FAULT EVALUATION REPORT FER-120

SUPPLEMENT NO. 1

October 29, 1981

San Andreas fault, northern San Mateo County area.

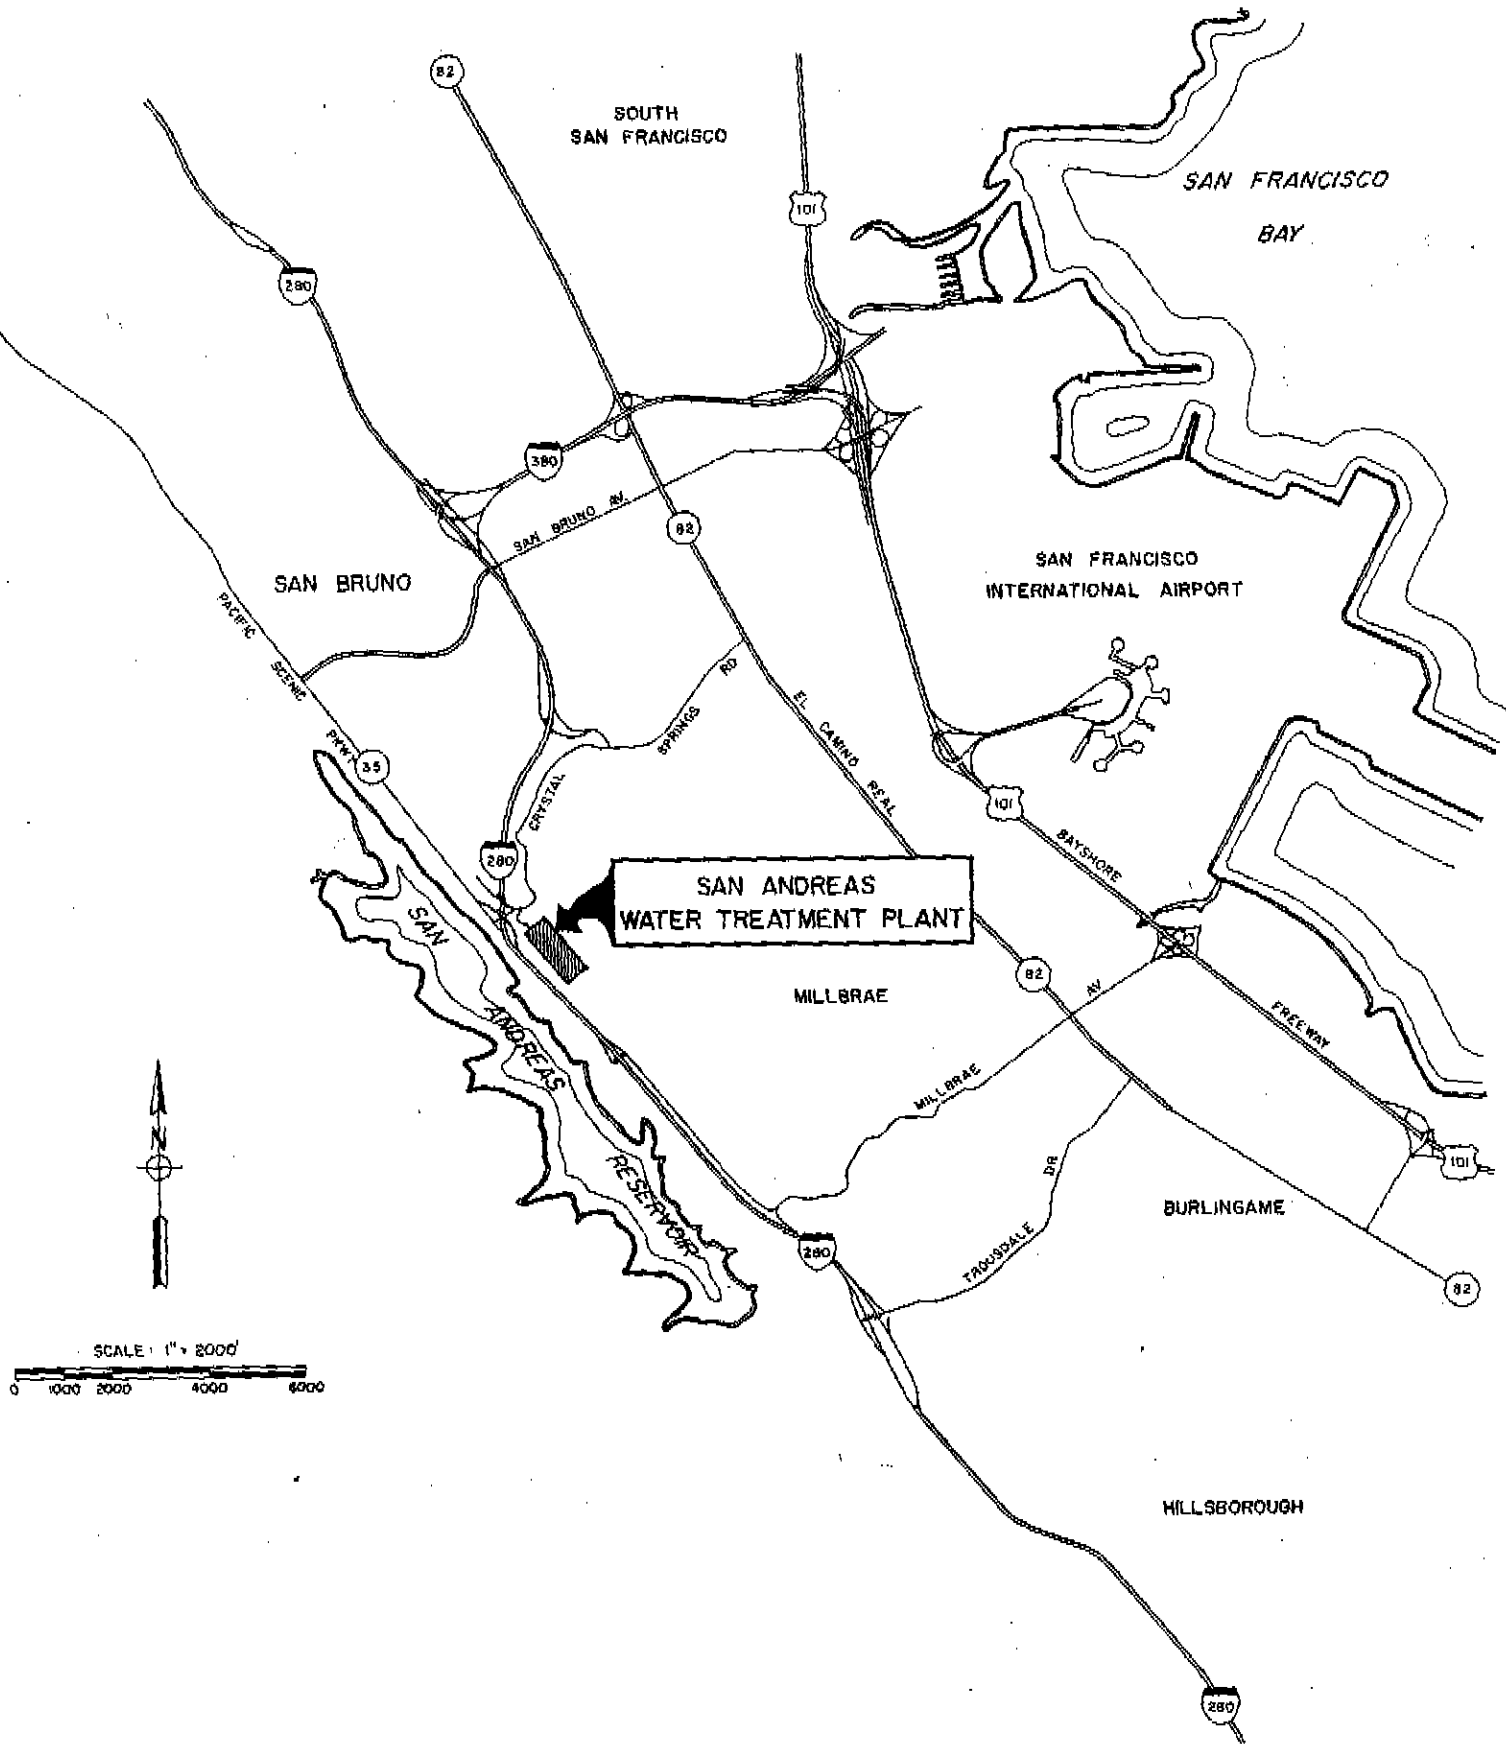
After the release of the Preliminary Review Maps by the California Division of Mines and Geology on 7/1/81, a geologic map of the Montara Mountain quadrangle was released by the U.S.G.S. (Pampeyan, 1981a). The location of the San Andreas fault shown by Pampeyan differs substantially from that shown on the preliminary review map in three places (see Fig. 1). At the northern end of San Andreas Lake,

Pampeyan depicts the active fault slightly to the west of that depicted by CDMG. Between San Andreas Lake and Lower Crystal Springs Reservoir, Pampeyan also depicts the fault slightly west of that shown by CDMG. He also cites the location of a pipeline ruptured by fault movement in 1906 near the eastern margin of the quadrangle (the third location).

Near the northern margin of the quadrangle, Pampeyan (1981a) shows two branch faults and two air photo lineaments, which he cites in his letter (1981b) as relatively young (see Fig. 1). He reports that the easternmost of these faults (Fault A) cuts Merced Formation and that <sup>a</sup><sub>A</sub> sag pond was visible along the fault on 1946 air photos. He shows the second fault (Fault B) as entirely in Franciscan material. He reports that two possible sag ponds were visible adjacent to the lineaments on the 1946 air photos.

Hall has forwarded a copy of a detailed, annotated map of the San Andreas fault between San Andreas Lake and Lower Crystal Springs Reservoir (Hall, 1981). According to Hall, the San Andreas fault has been identified in trenches at several locations (see Fig. 1). He also has verified locations of the 1906 rupture. Hall (1981) and Pampeyan (1981) generally agree on the location of the most recently active faults, differing slightly in detail. Both Hall and Pampeyan commented that several of the features depicted on Figure 3B in FER-120 between the lake and the reservoir follow a pipeline and are artificial.

USDA (1941) photos # 29-31 were re-examined for this supplemental report. The sag pond reported by Pampeyan (1981a; 1981b) along fault A (Fig. 1) was indeed present. Several other sag ponds were also present a few thousand feet to the north in the San Francisco South quadrangle. The latter ponds are fairly clearly due to

As a result of this re-evaluation, the following changes to the SSZ map appear appropriate (see Fig. 2):

1. Add a fault beneath Lower Crystal Springs Reservoir as shown on Fig. 2.
2. In the area between the reservoir and the lake, show the faults mapped by Hall (1981) and delete those shown on the preliminary map.

3. Add the fault shown by Pampeyan (1981) beneath San Andreas Lake.
  4. Add faults A and B to the map, modifying the Special Studies Zone slightly.
  5. Do not show the air photo lineaments of Pampeyan.
9. Investigating geologist; date.

Figure 3. Air photo interpretation, with annotations from Larson, and  
others (1906).

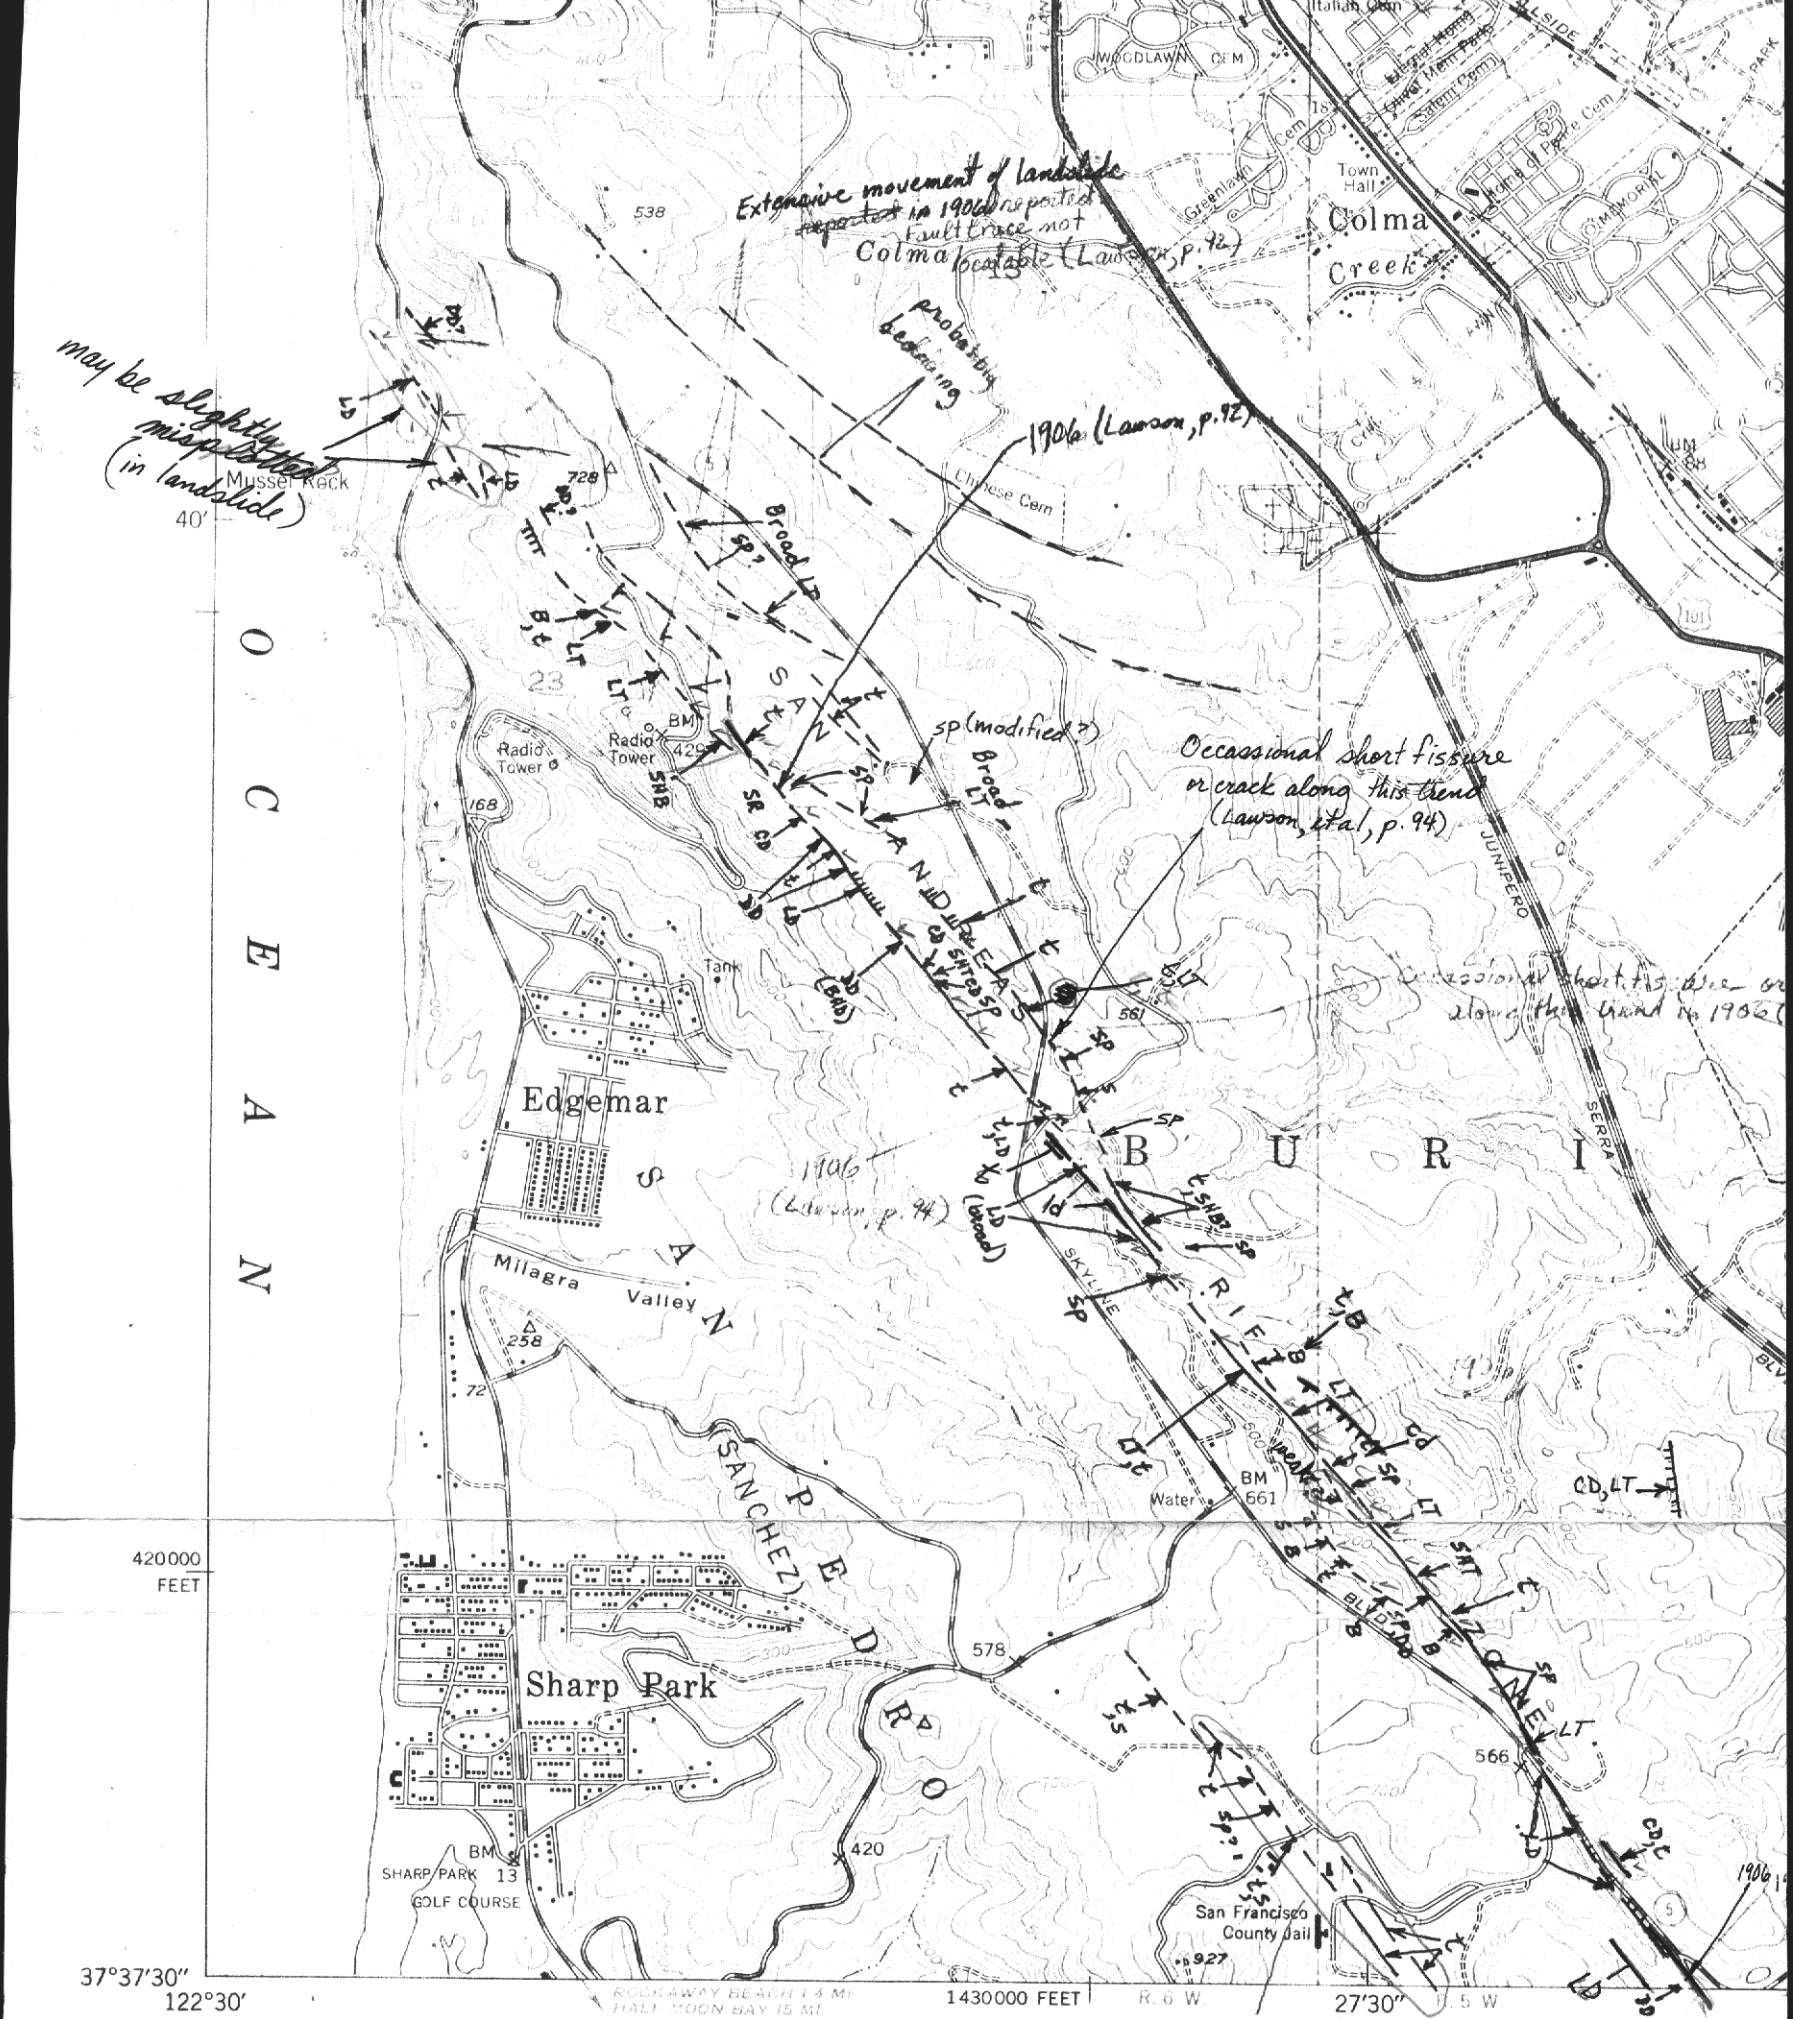
The fault trace mapped by Pampeyan beneath San Andreas Lake could not be observed since the lake was at its highest level in 1941. The photos do clearly show two small linear sag ponds along the trace delineated on the preliminary review map (see Fig. 3B in FER-120).

Based on the detailed mapping by Hall (1981) and Pampeyan (1981a), it appears that several of the features shown on Fig. 3B of FER-120 between Lower Crystal Springs Reservoir and San Andreas Lake are artificial. Also, the main recent fault break appears to be west of that shown on the preliminary review map in the area between these two lakes. To the south, the reported pipeline offset suggests the 1906 break lies slightly west of that shown on the preliminary review map. Also, based on Pampeyan's (1975; 1981) maps, it appears there is an additional Holocene fault beneath part of San Andreas Lake south of John Muir School.
